INDESIT company

Model type:
WITP102EU

Commercial code:
F034266

n1040345: Replacement of drum lock button TL EVOII.

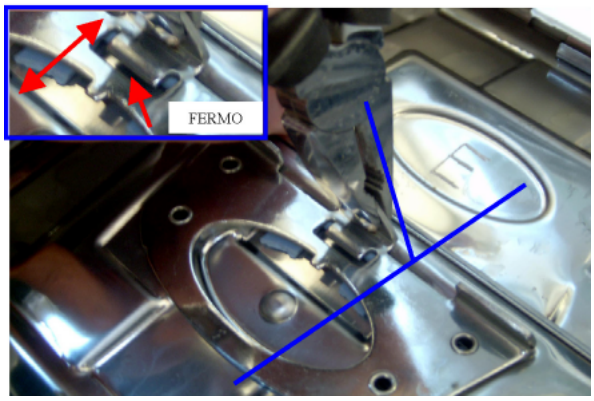
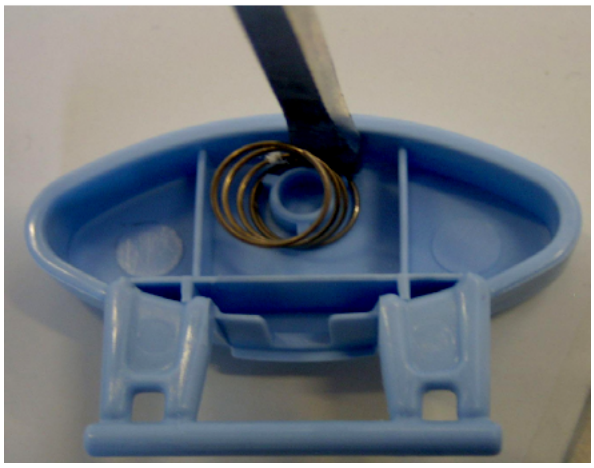
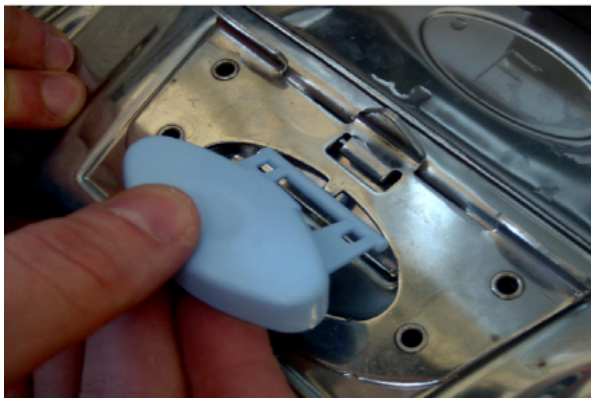
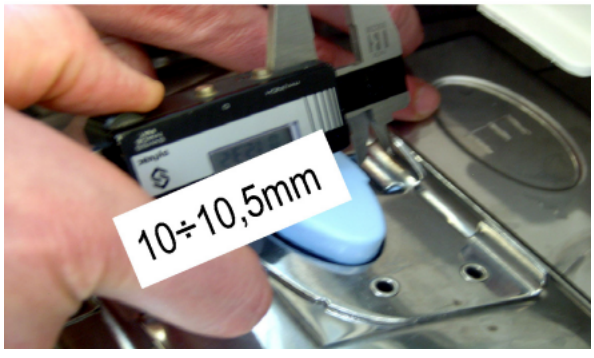
Tools and material needed: pliers, screwdriver, gauge, spring P/N Sat 114989, button P/N Sat 114990.

1) turn the central tip of the catch in the direction shown (FIG.1);

2) bring the tip to a vertical position and ensure that the broken button is disengaged from the catch restraint and can be removed (FIG.2);

3) remove the remaining part of the button with the aid of a screwdriver, taking care not to scratch the doors (FIG.3);

4) pre-assemble spring to button (FIG.4);

5) insert button between catch and door (FIG.5);

6) bring the button into position and arrange the spring in its location in the door (FIG.6);

7) turn the central tip of the catch in the direction shown to return it to its starting position (FIG.7);

8) check the distance between button and catch (FIG.8);

9) check correct operation of the button when opening and closing the doors (slight inclination errors of the catch can result in

faulty closing of the doors) (FIG.9).

n1040382: Drain pump with bayonet-style filter - top Loading Brembate

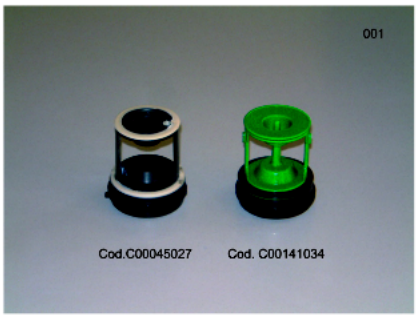
From serial no. 51021.0001 a new drain pump with bayonet-style filter has been installed on all top loading washing machines manufactured in Brembate.

New parts:
C00141862 - Drain pump
C00141034 - Pump filter kit

Premodification parts:
C00111409 - Drain pump
C00045027 - Pump filter kit

The new parts can be used instead of premodification ones.

n1040404: New pulley installed on top loading washing machines up to 1000RPM (NO tub lock)

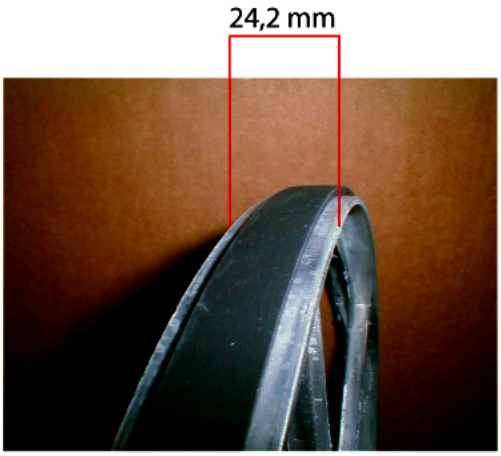
From serial no. 51202.0001 the pulley track has been widened from 21.2mm to 24.2mm (see picture N1040404FIG1).

new pulley
C00142832 - D280 24.2 mm track

Premodification pulley
C00083912 - D280 21.2 mm track

The new pulley can also be used on premodification versions of the models referred to in this release.
